Tweed Valley Hospital Stage 2 Modification 3

Amendments to Multi-deck Carpark
State Significant Development Modification Assessment
(SSD-10353-Mod-3)

May 2022

Figure 4 | Proposed material changes to façade for the southern elevation of the multi-deck carpark (Source: SSD-10353-Mod-3 Architectural Plans)

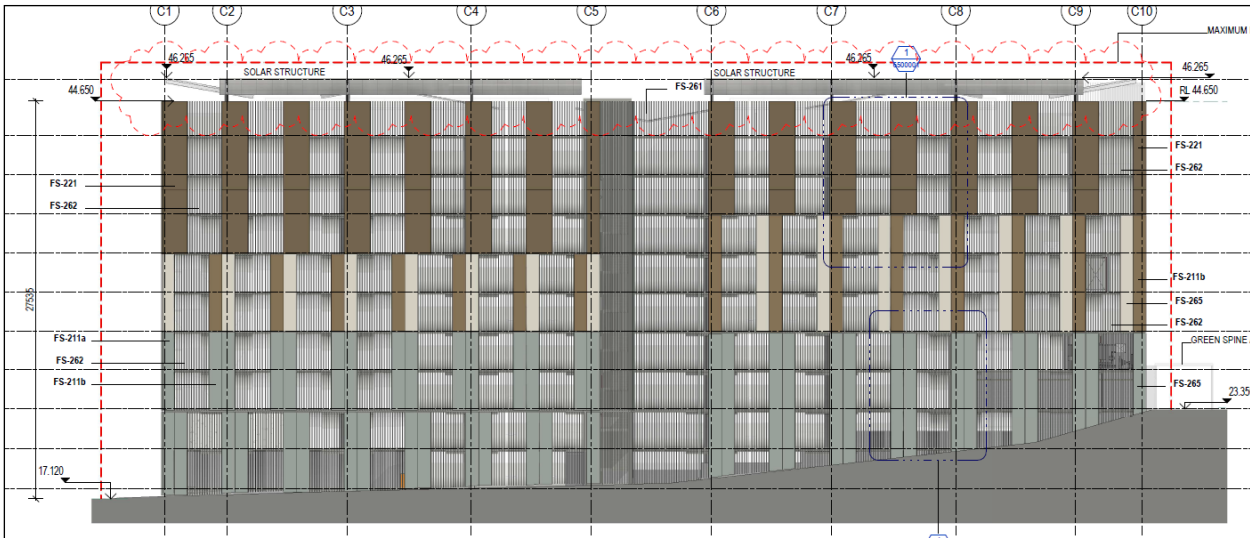
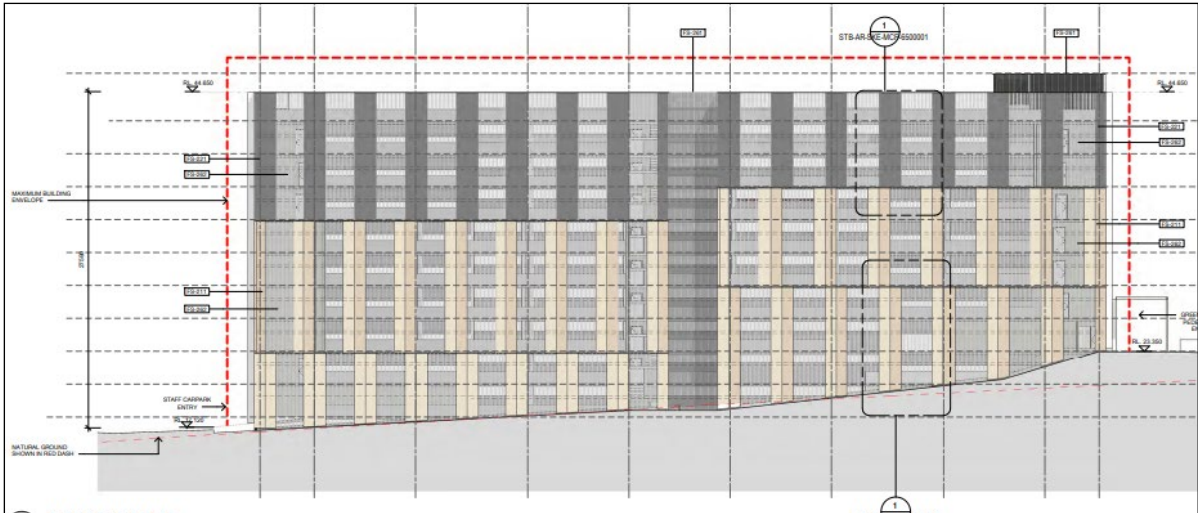
- the proposal should be reviewed by the Applicant's acoustic consultant to ensure the development meets the operational use noise objectives and recommendations.
- the original 'green wall' should be reintroduced into the façade design of the multi-deck carpark.
- the material changes should be reviewed by the State Design Review Panel (SDRP) to ensure design quality.

The façade materials for the multi-deck carpark are proposed to be altered from a pre-cast concrete solid structure to a lightweight perforated aluminium panel system. This change has been proposed so that natural ventilation for the structure can be achieved. The change in materials allows for this to occur whilst also being a more cost-effective material.

The Applicant has also provided a BCA Report and a Fire Assessment Report demonstrating that the material changes to a lightweight perforated aluminium panel are required to achieve compliance with the BCA. This information also outlined that the originally proposed 'green wall' would result in a BCA non-compliance (in terms of natural ventilation requirements and fire safety) and as a result has been removed from the development. Council requested that the 'green wall', which was depicted in earlier photomontages in the original SSD application, be retained to enhance the visual appearance of the carpark.

Given the information provided and the existing conditions of consent requiring ground level planting to soften the visual appearance of the structure, the Department supports the removal of the green wall as its inclusion would result in a BCA non-compliance. The Department further notes that the approved landscape plans do not show any form of green wall on the carpark.

The architectural plans depict minimal change in visual appearance from the previously approved design and will not result in visual impacts as depicted in **Figures 7** and **8** below. The material changes are required to achieve BCA compliance and are of similar style to the original design. Therefore, the Department does not consider that the modification requires further consultation with the SDRP. The changes are appropriate and can be supported by the Department.

Figure 5 | Elevation of proposed rooftop solar PV structures (Source: SSD-10353-Mod-3 Solar Report)

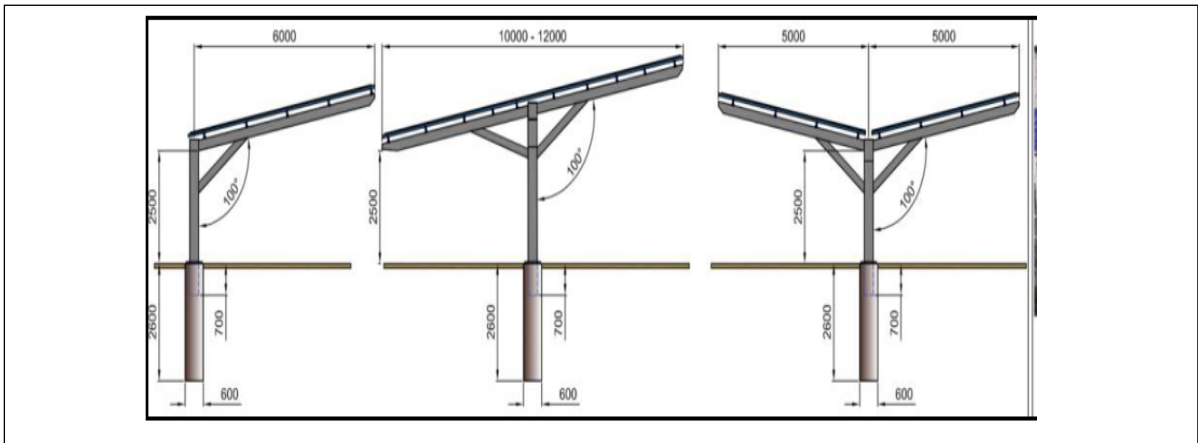
The panels will result in a minor increase in the overall building height of 115mm (from RL46.150 to RL46.265). The height increase will not result in enough of a change that will be visually discernible and the site is not subject to a maximum building height. The minor height increase is also within the approved building envelope under the concept proposal.

The Department concludes that the proposed solar PV panels do not result in any adverse impact to the site or surrounding environment. Despite the panels contributing to a minimal increase in building height, the changes will result in improved amenity as more shade cover will be provided for users of the roof of the multi-deck carpark and will make the development more ecologically sustainable. The solar PV panels can be supported given the negligible environmental impacts and improved sustainability outcomes.

Figure 6 | Proposed section showing level changes for multi-deck carpark (Source: SSD-10353-Mod-3 Architectural Plans)

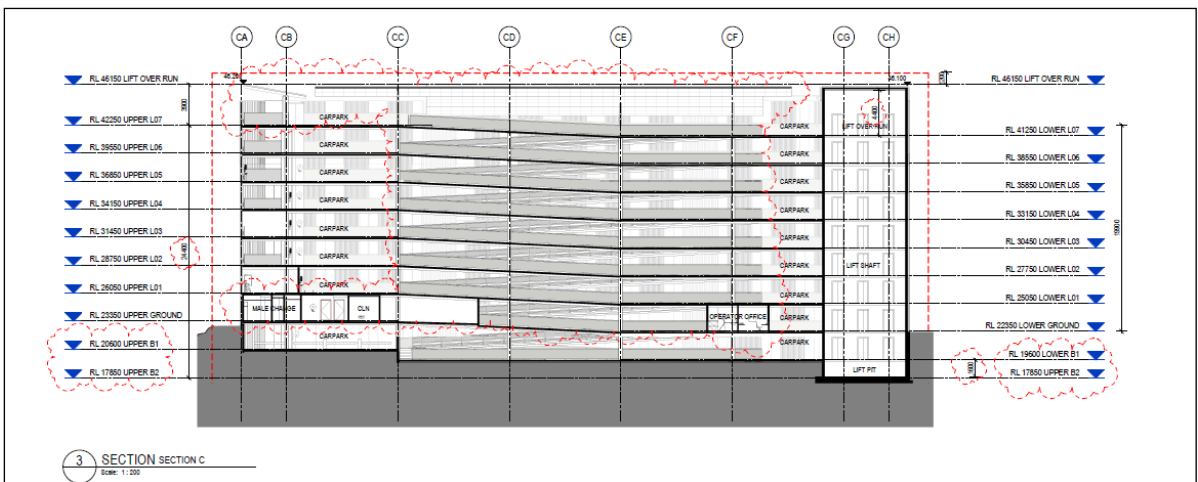
The modification also proposes minor earthworks to lower the carpark a further 100mm into the ground across the two basement levels. The degree of additional earthworks is minimal and will not have an adverse impact on the natural landscape, but will assist in providing a more functional carpark. The Department's assessment concludes that the alterations to the carpark would not adversely impact on neighbouring sites and would provide a more efficient and functional development. Therefore, the Department considers the design changes acceptable.
